**MODIFICATIONS TO
CONTRACT EROSION PREVENTION
AND
SEDIMENT CONTROL (EPSC) PLAN**

FAIRFIELD BRO 1448 (41)

(Elm Brook Rd, TH#47, Bridge 46, Fairfield, VT)

EPSC NARRATIVE AMENDED

OFF-SITE ACTIVITY SUBMITTAL

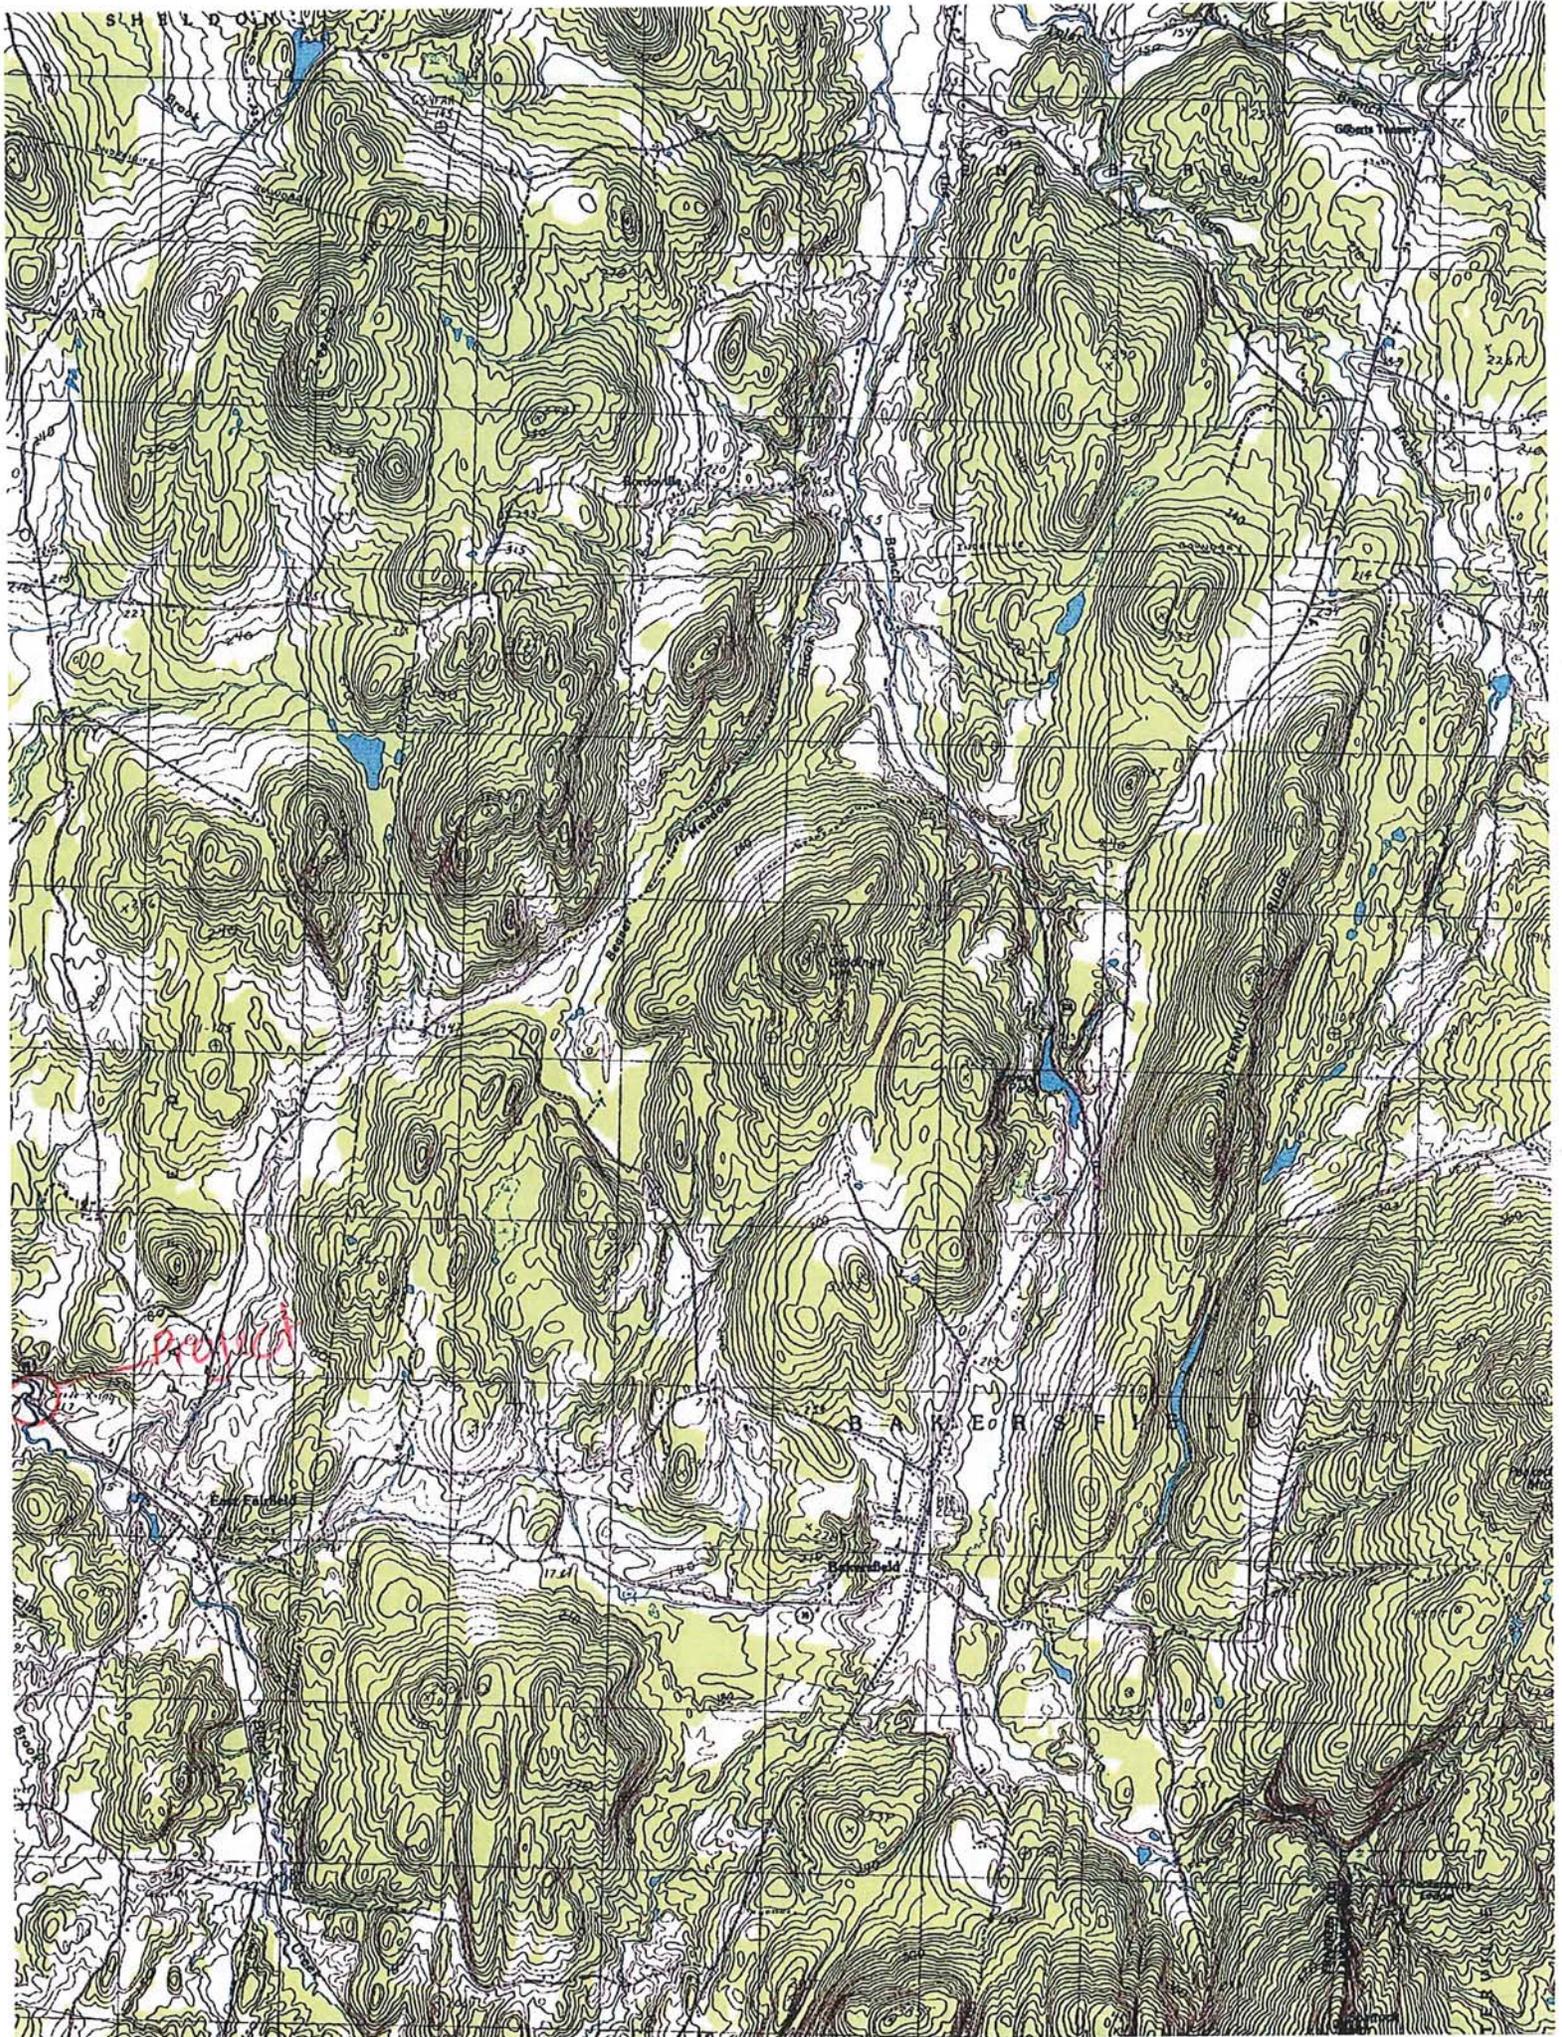
Staging what?
 If applicable, how much?
 Property located in?
 sketch
 Looks like 3 sites
 YES or NO?
 Better map.
